**AMENDMENT TO THE  
PRELIMINARY DRAINAGE REPORT  
for  
WINDERMERE**

Colorado Springs, CO

**January 20, 2020**

**Drexel, Barrell & Co.**

**WINDERMERE  
 PRELIMINARY PLAN**  
 N. MARKSHEFFEL ROAD  
 EL PASO COUNTY, COLORADO

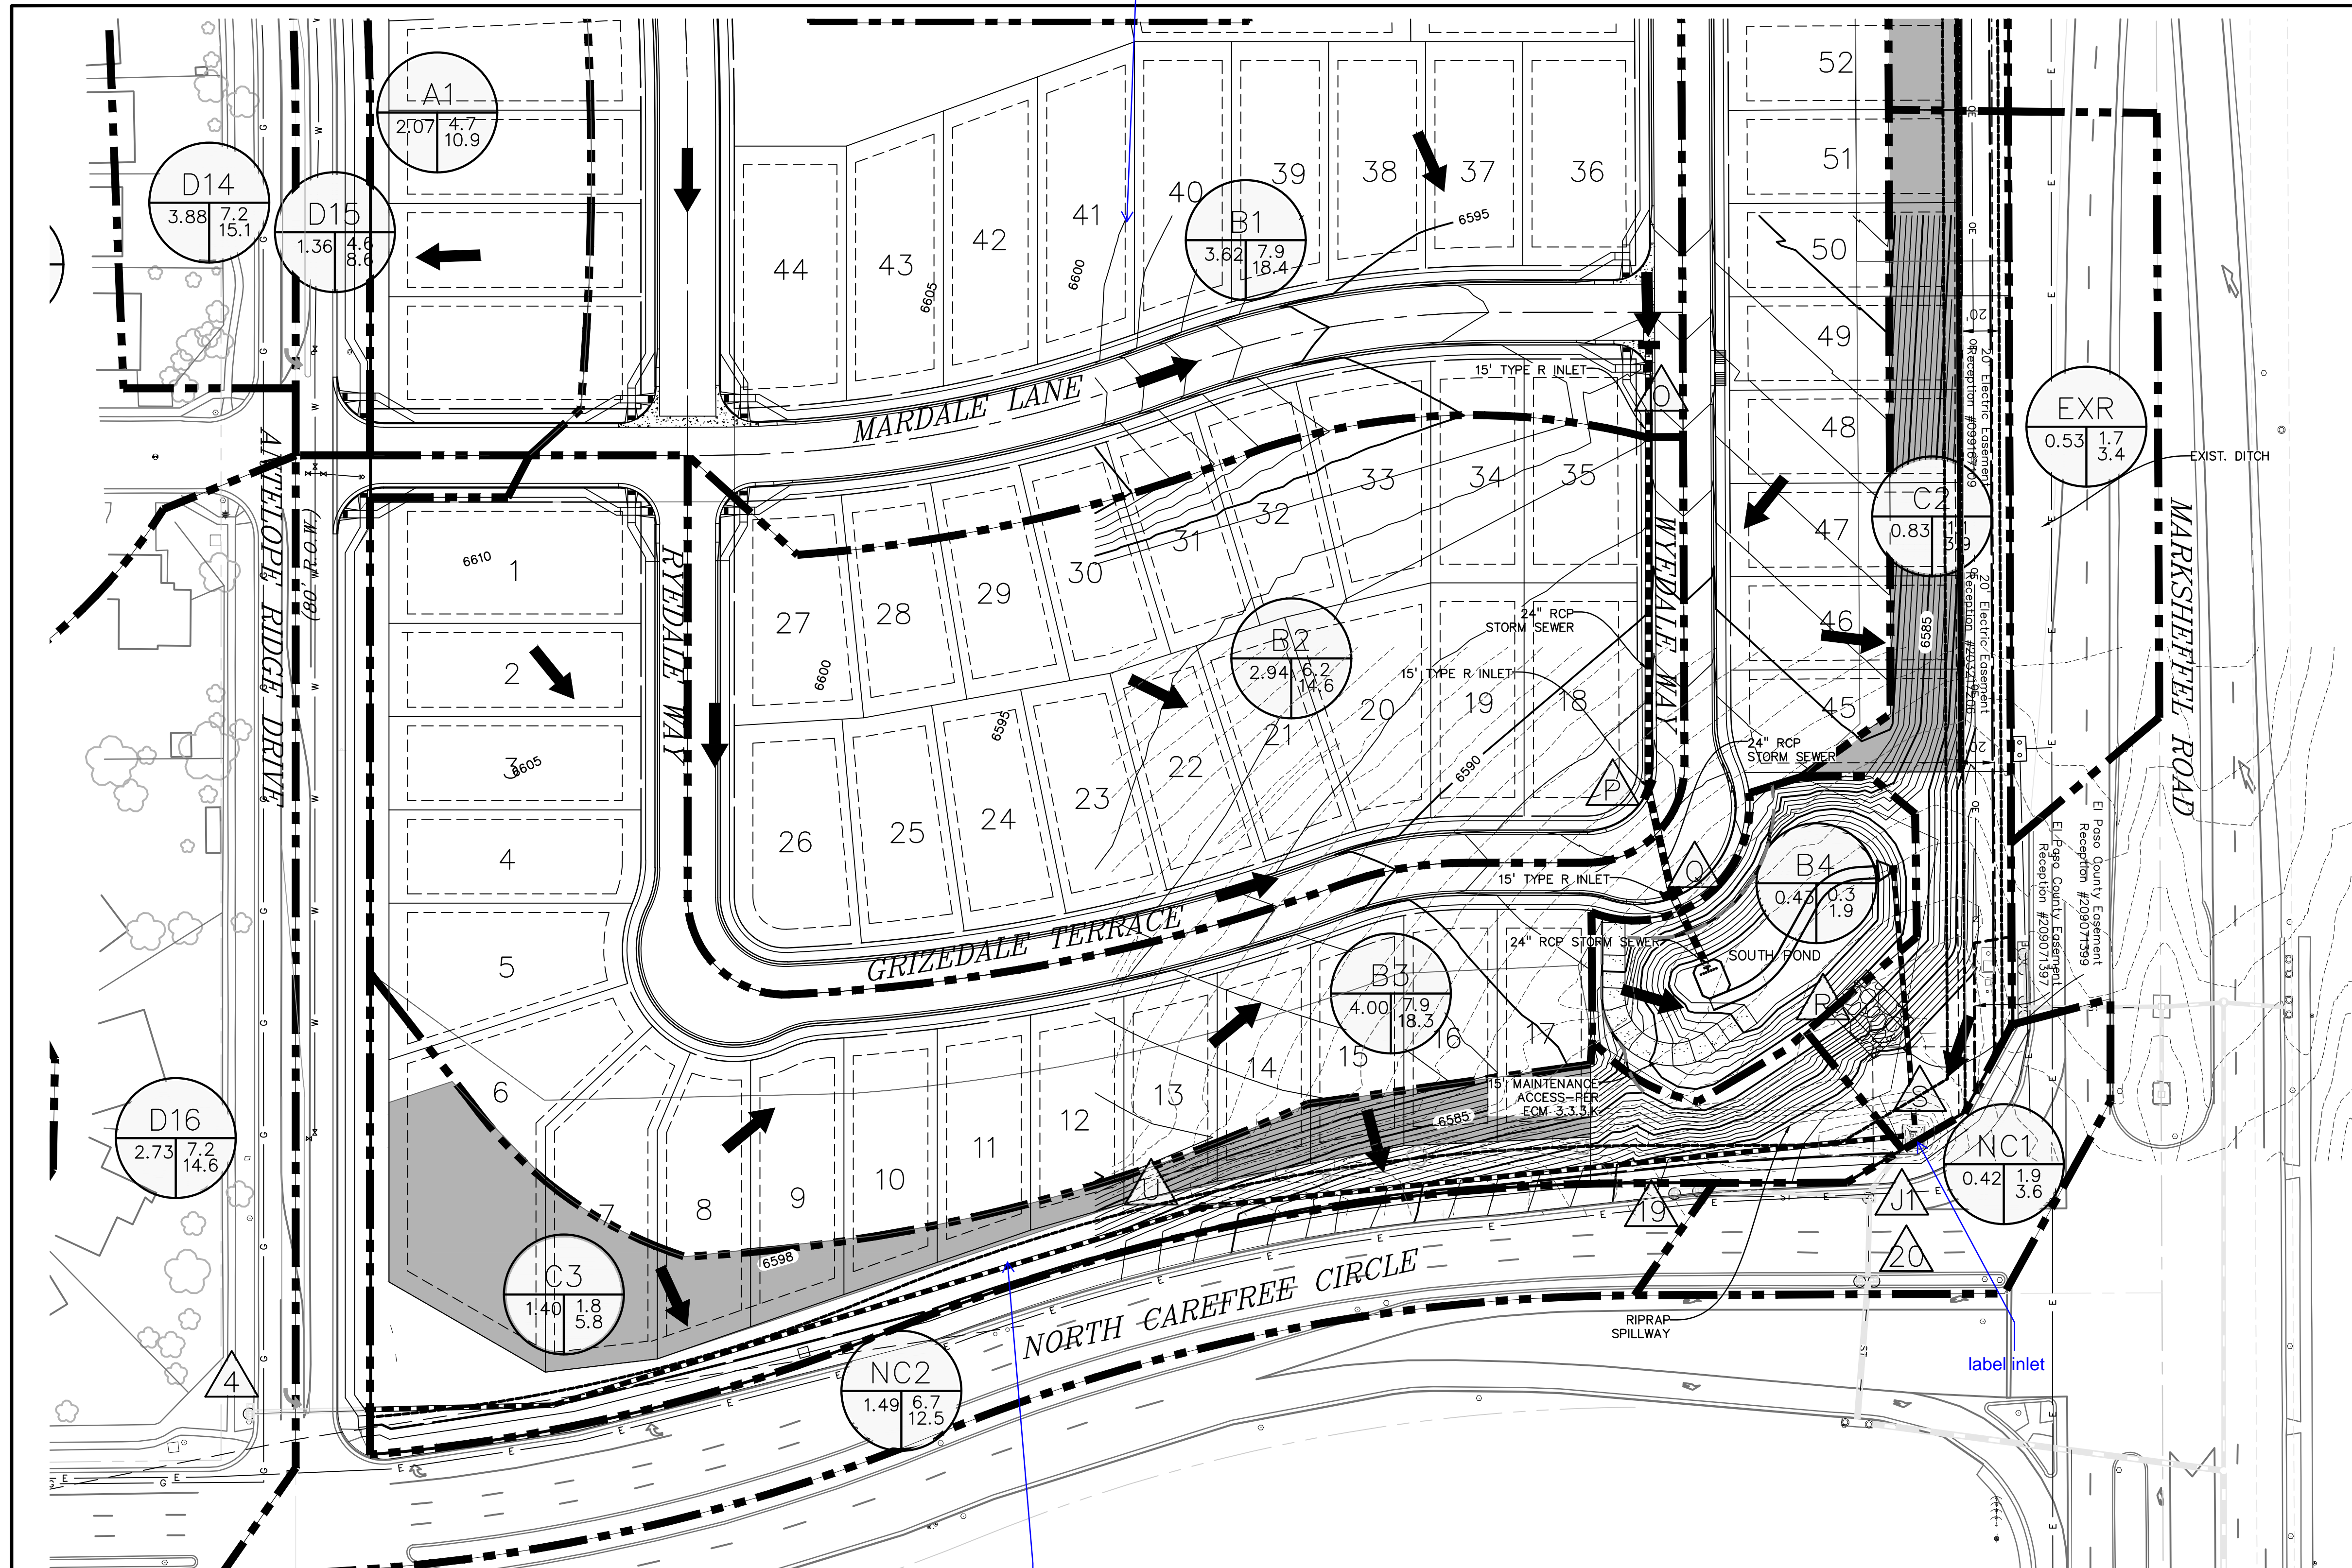
show emergency overflow path and grading

contours are cut off - show all

**WINDERMERE  
 PRELIMINARY PLAN**  
 N. MARKSHEFFEL ROAD  
 EL PASO COUNTY, COLORADO

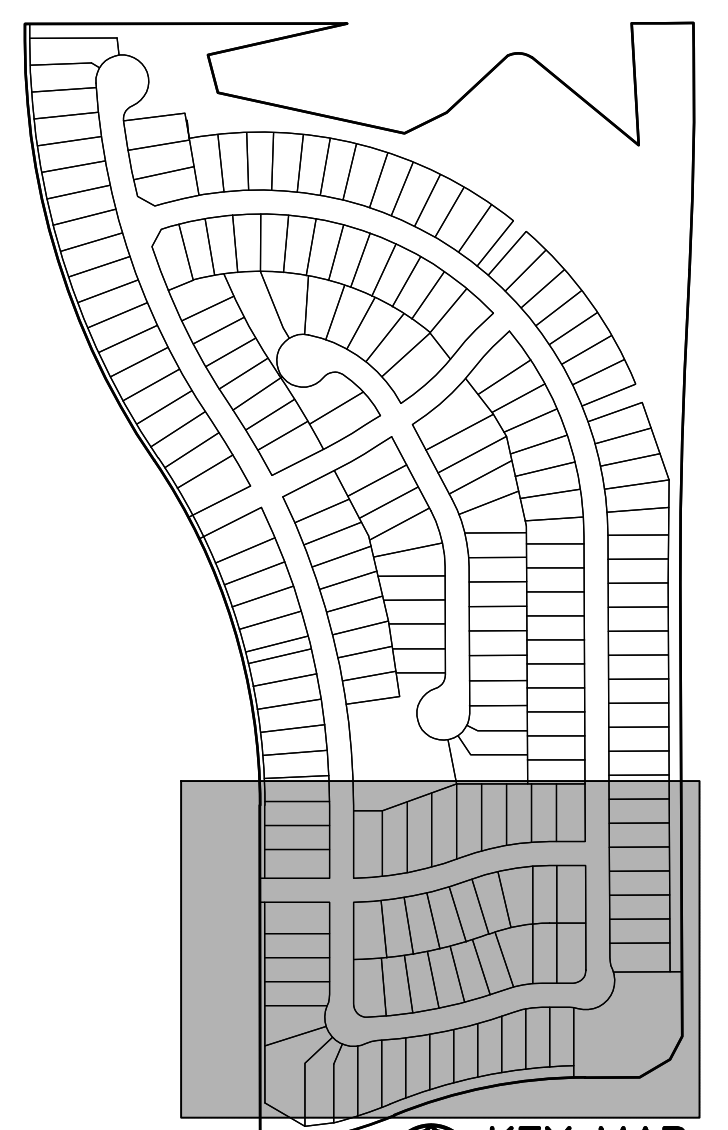
label inlet
